S4.55(2) MODIFICATIONS - GROUND LEVEL

NEW HOSPITALITY VENUE  
PARRAMATTA  
FOR CASTLE HILL RSL CLUB

TITLE  
GROUND FLOOR PLAN

S4.55(2) MODIFICATIONS - FIRST FLOOR

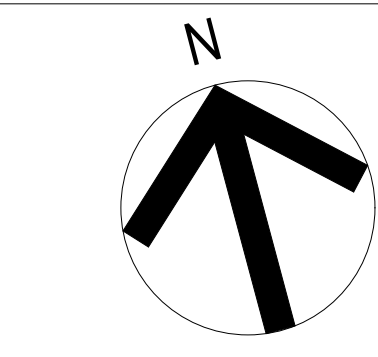
1. ADMINISTRATION RELOCATED TO BASEMENT LEVEL

S4.55(2) MODIFICATIONS - GROUND LEVEL

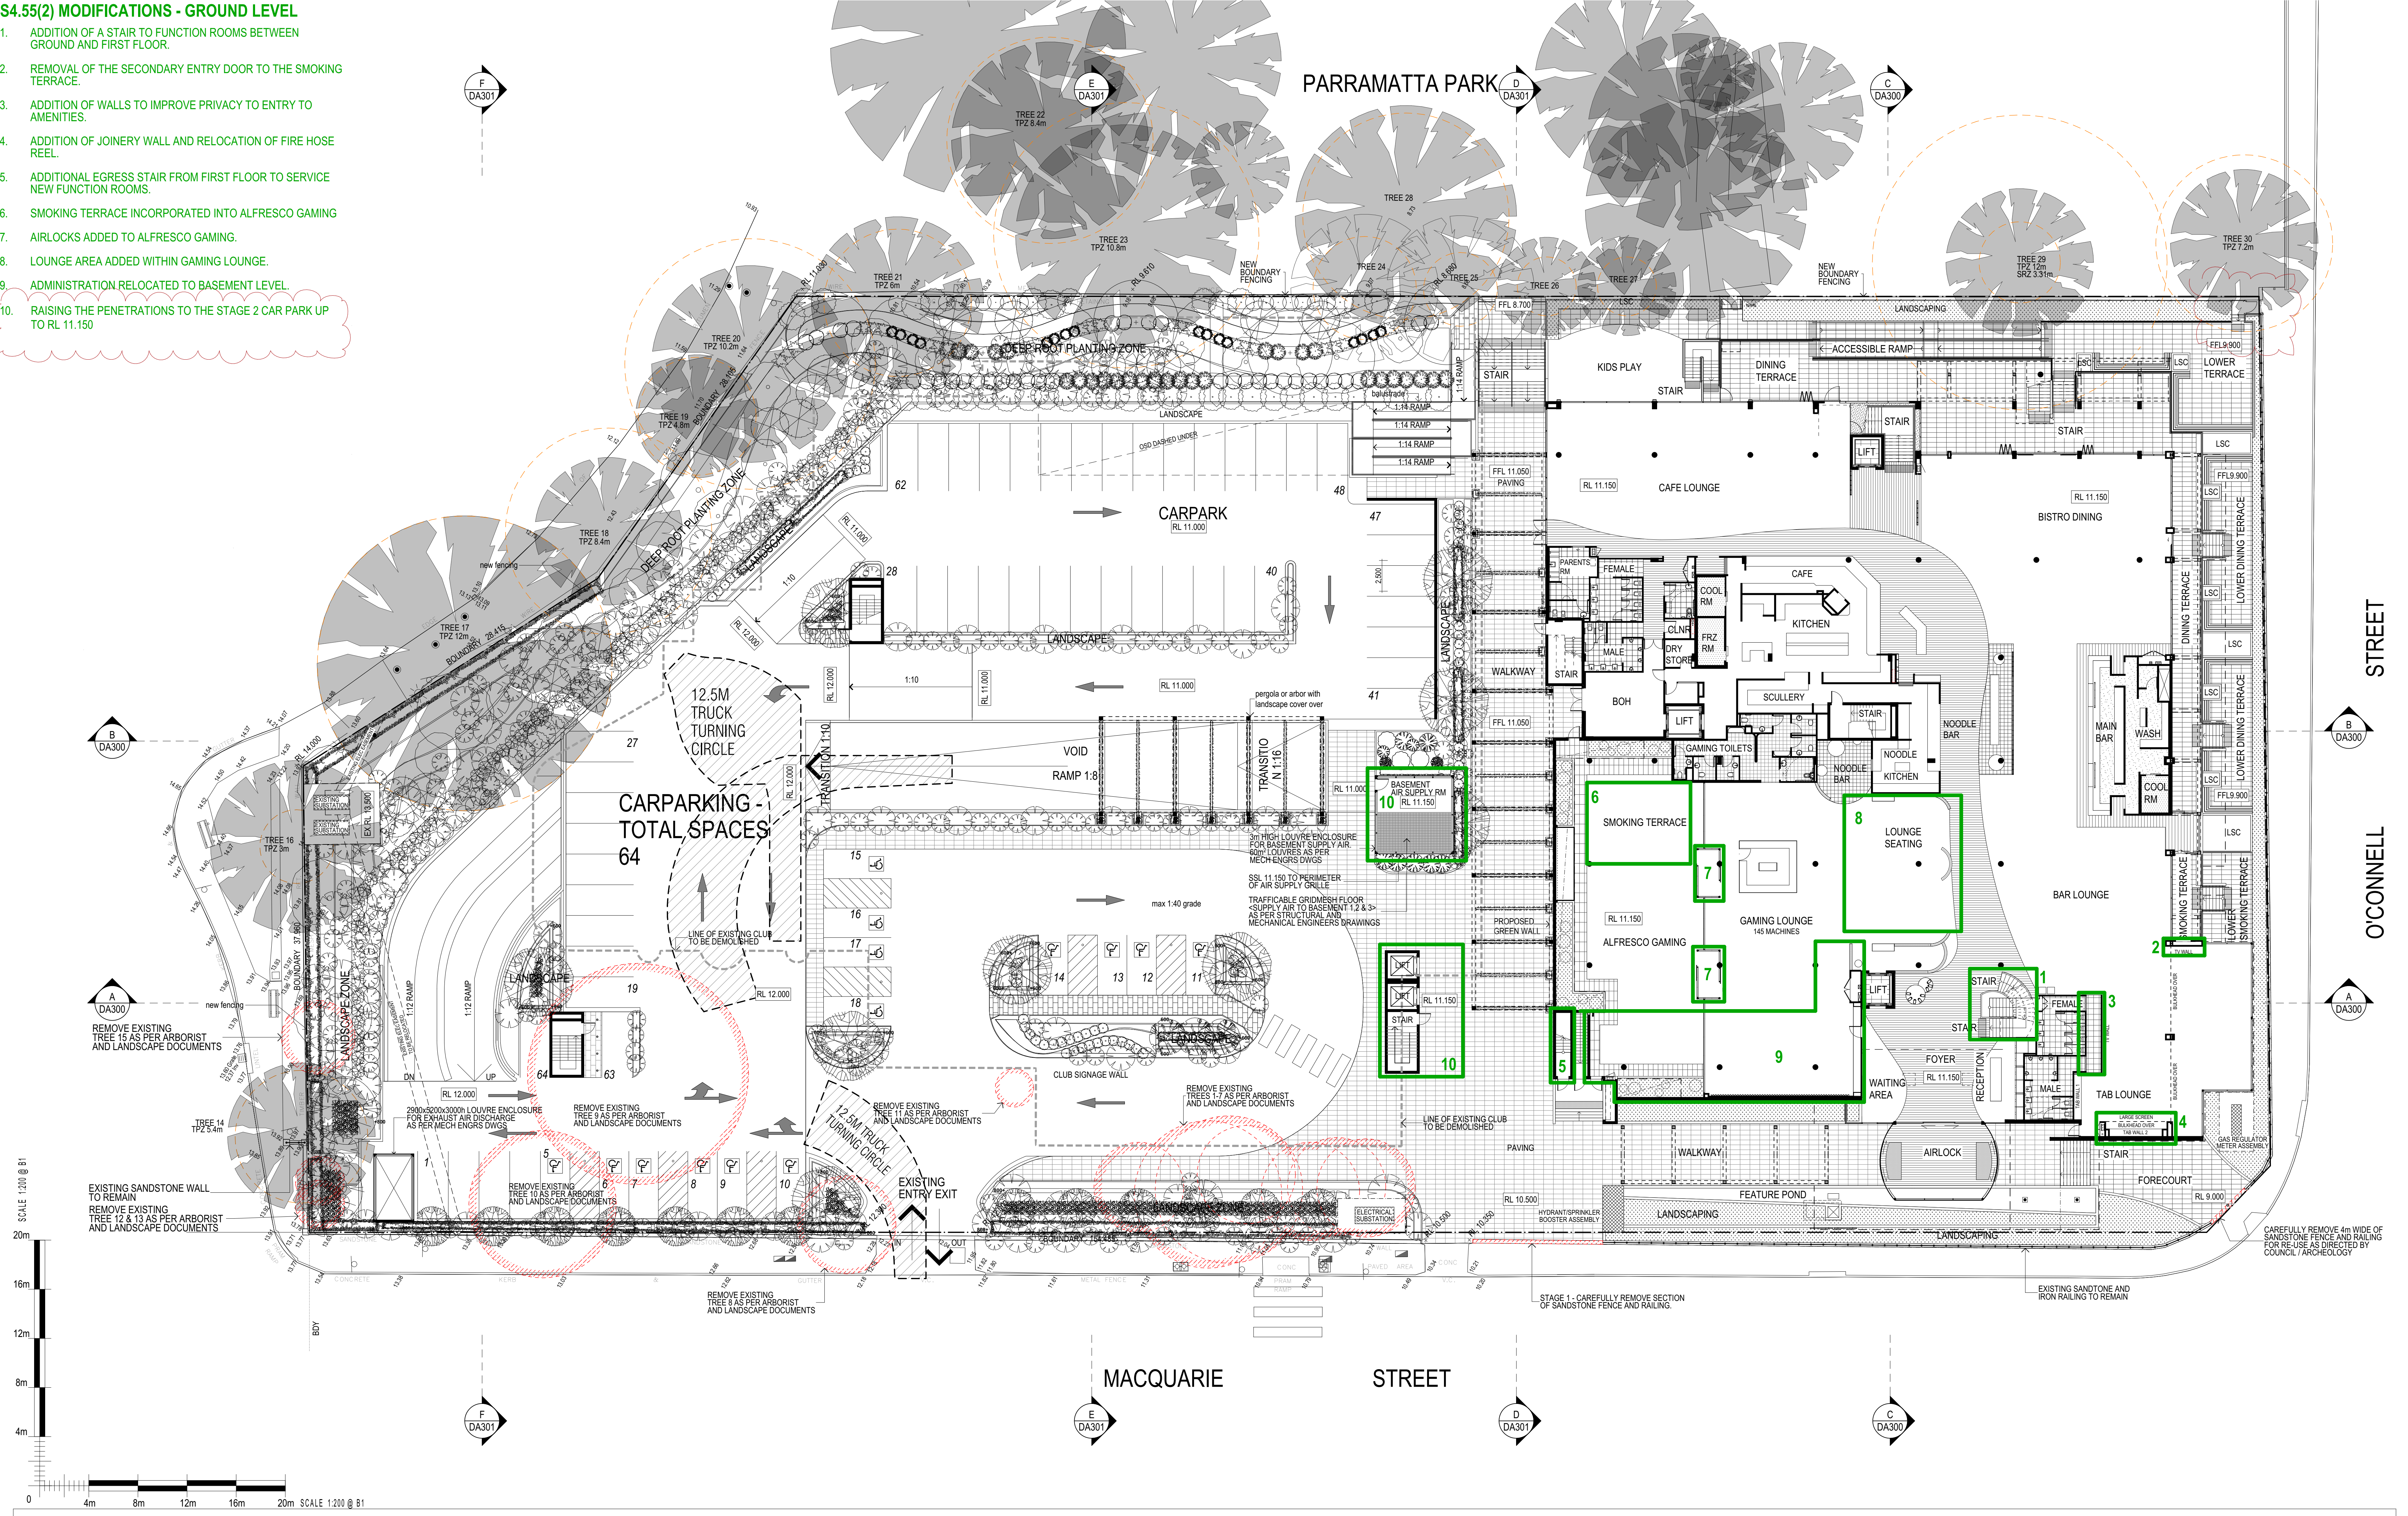
1. ADDITION OF A STAIR TO FUNCTION ROOMS BETWEEN GROUND AND FIRST FLOOR.
2. REMOVAL OF THE SECONDARY ENTRY DOOR TO THE SMOKING TERRACE.
3. ADDITION OF WALLS TO IMPROVE PRIVACY TO ENTRY TO AMENITIES.
4. ADDITION OF JOINERY WALL AND RELOCATION OF FIRE HOSE REEL.
5. ADDITIONAL EGRESS STAIR FROM FIRST FLOOR TO SERVICE NEW FUNCTION ROOMS.
6. SMOKING TERRACE INCORPORATED INTO ALFRESCO GAMING.
7. AIRLOCKS ADDED TO ALFRESCO GAMING.
8. LOUNGE AREA ADDED WITHIN GAMING LOUNGE.
9. ADMINISTRATION RELOCATED TO BASEMENT LEVEL.
10. RAISING THE PENETRATIONS TO THE STAGE 2 CAR PARK UP TO RL 11.150

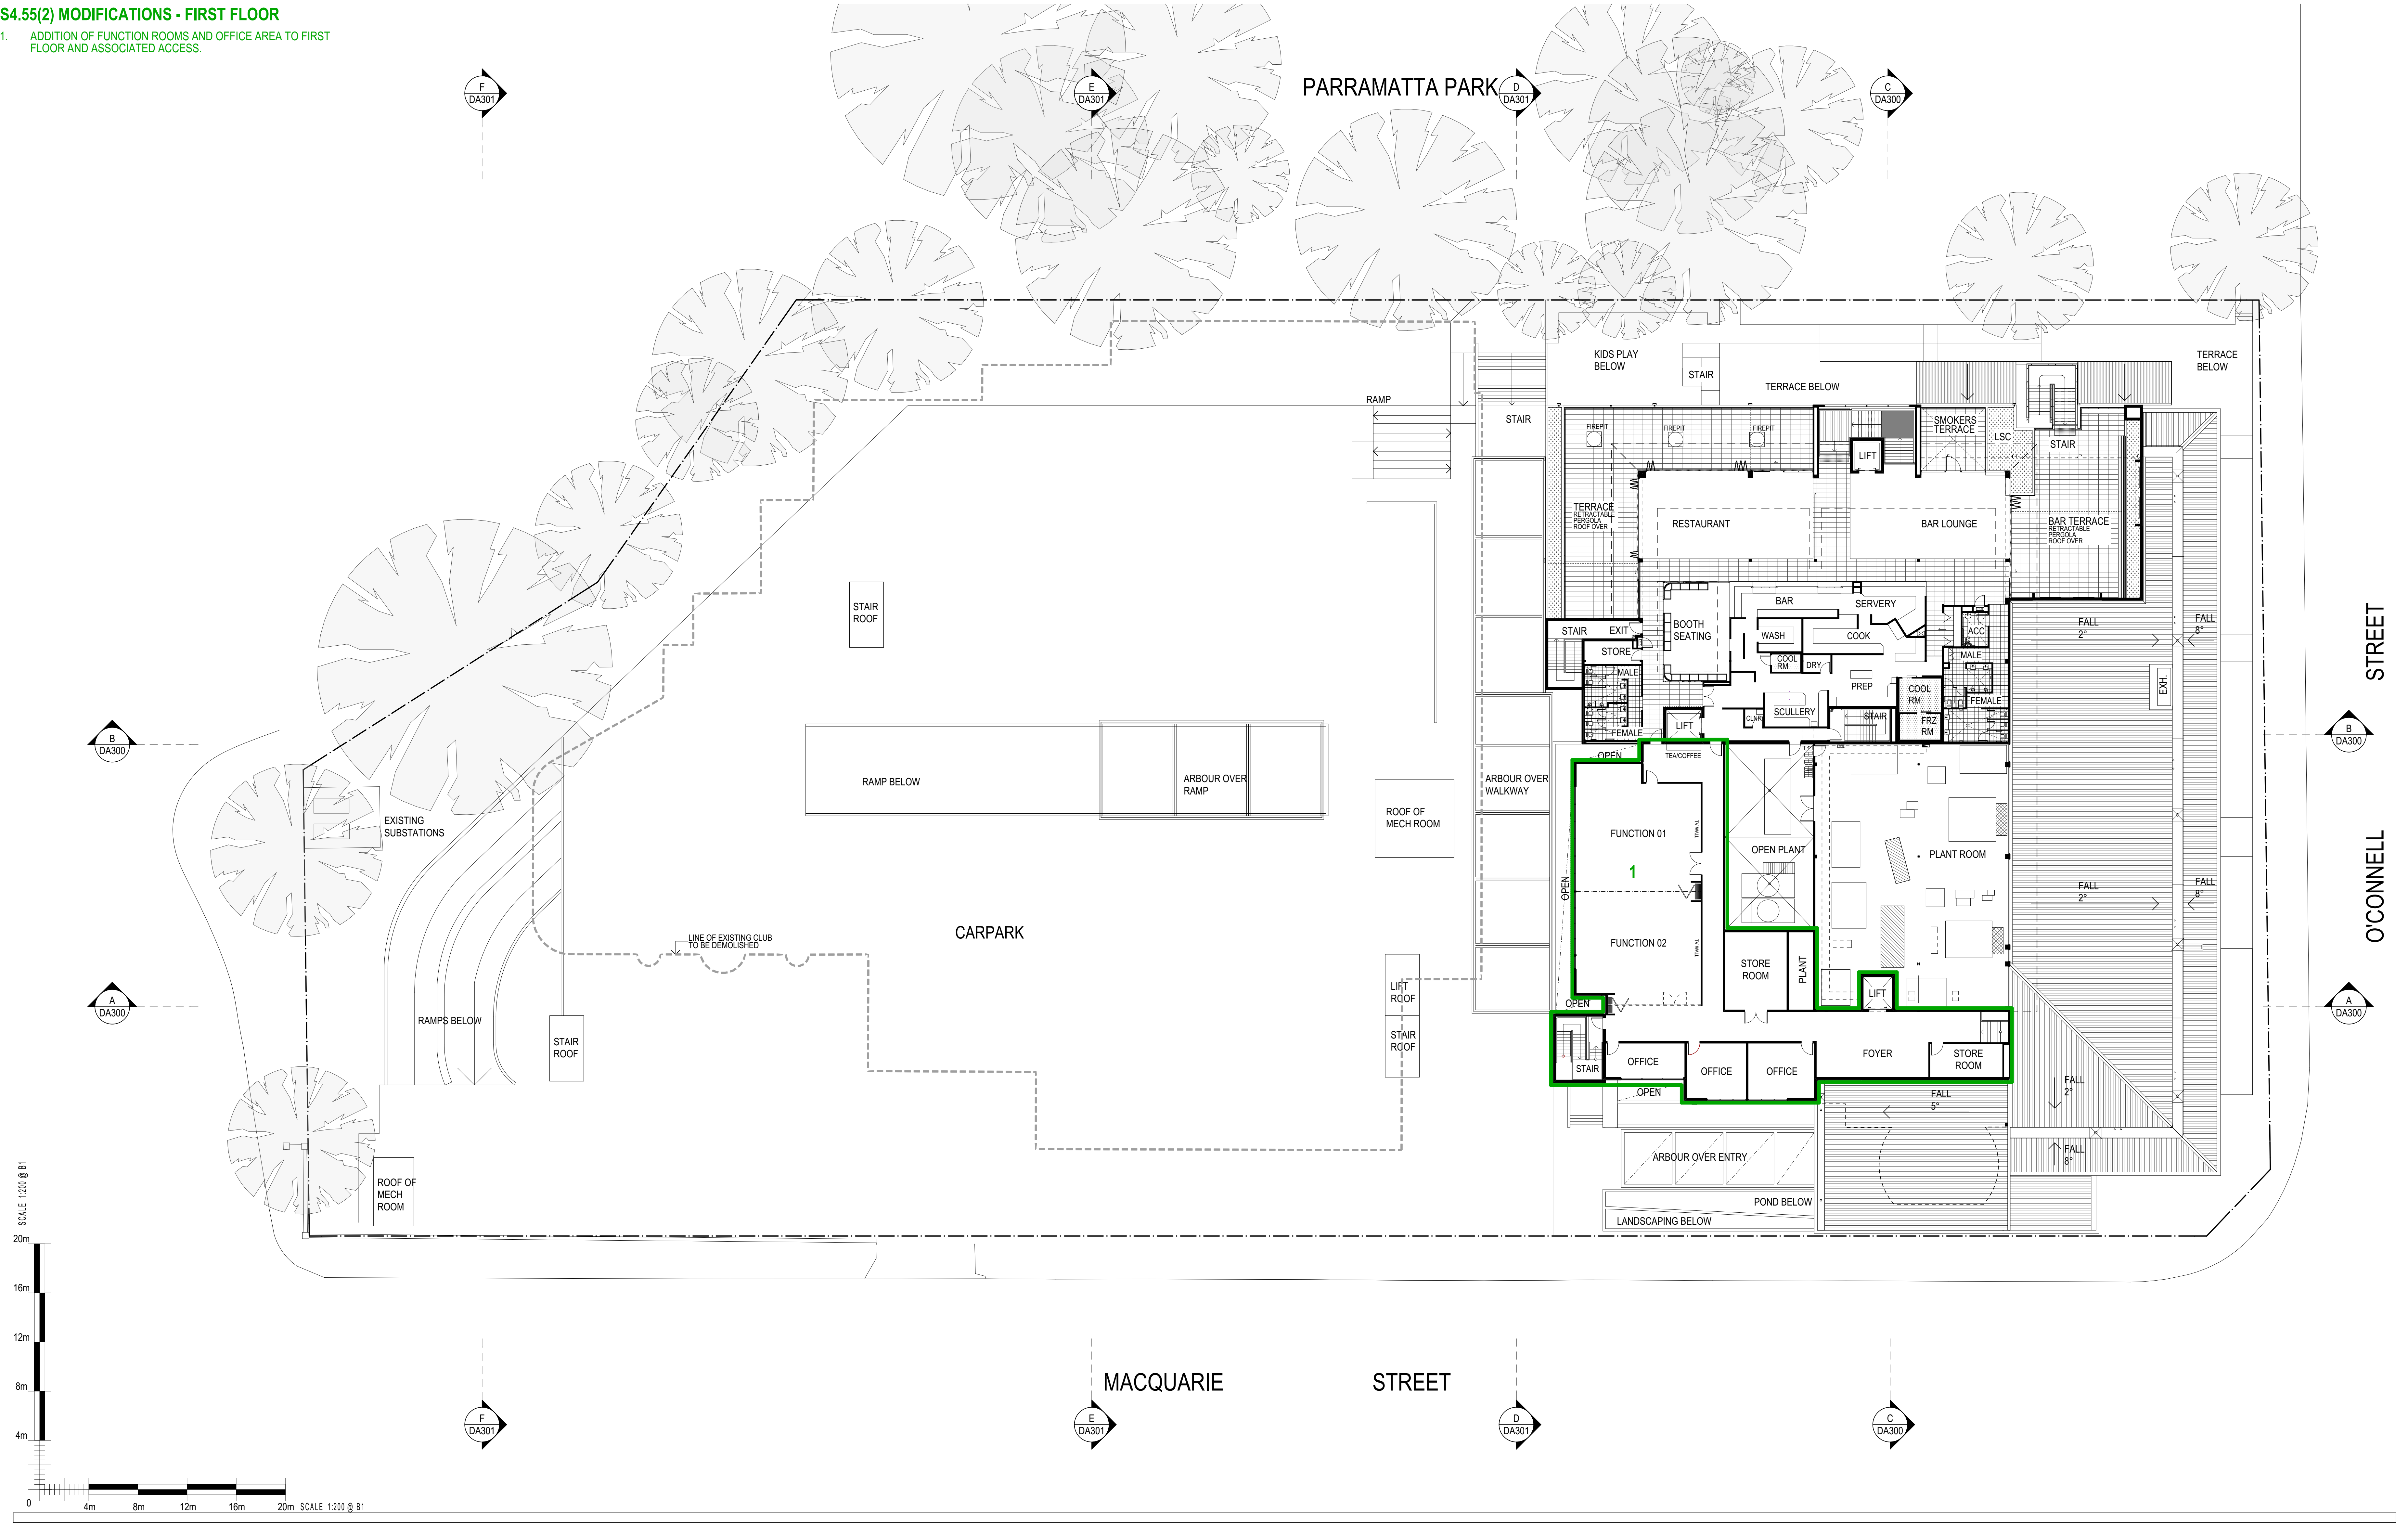
1. ADDITION OF FUNCTION ROOMS AND OFFICE AREA TO FIRST FLOOR AND ASSOCIATED ACCESS.

S4.55(2) MODIFICATIONS - ROOF LEVEL

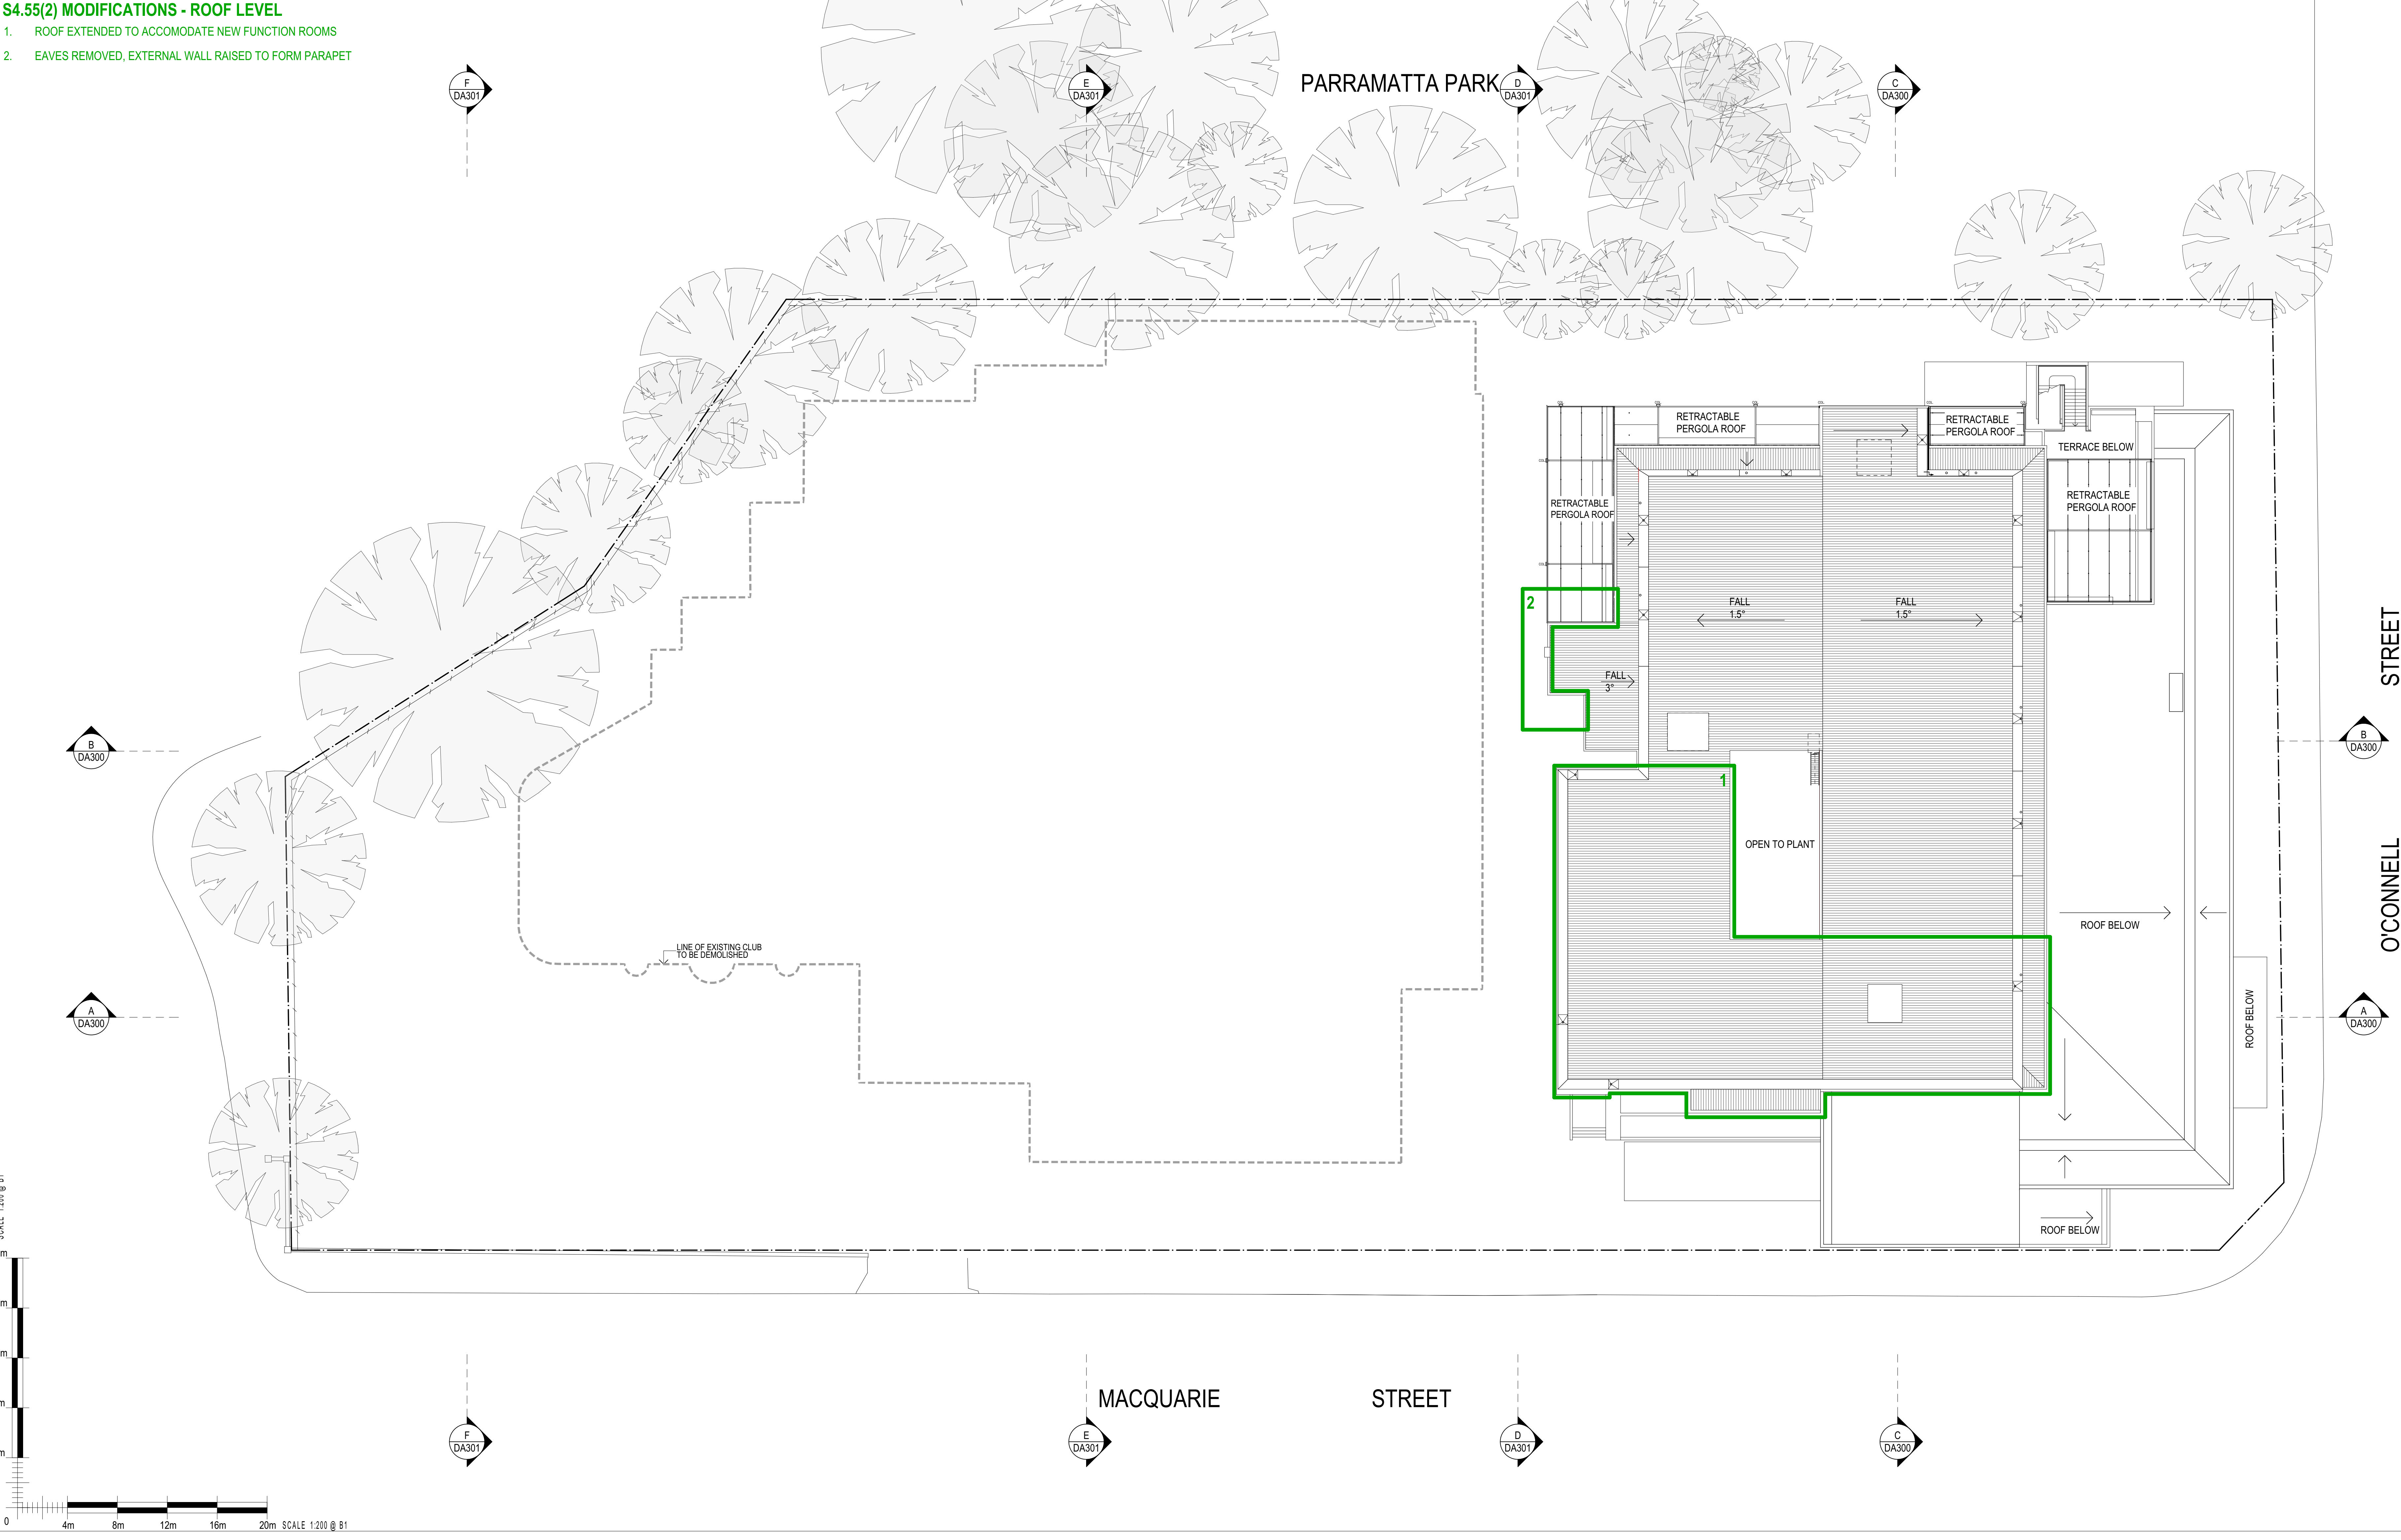
1. ROOF EXTENDED TO ACCOMODATE NEW FUNCTION ROOMS
2. EAVES REMOVED, EXTERNAL WALL RAISED TO FORM PARAPET
